Access Compliance Report Public Rights-of-Way (Curb Ramps)

Main Street: BOSTONIAN_DR Cross Street: WEMBLEY_RD Location: NW

ADA ID: RPRK211220125704 Ramp Type: Type 1 - Perpendicular Diagonal Initial Pass/Fail: Pass Overall Compliance: No Severity Score: 4

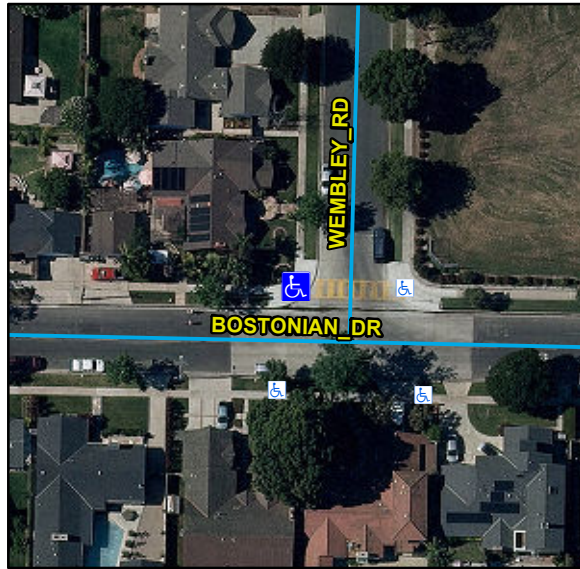
R304.2.1, STD 1115

Remove & Replace Landing.
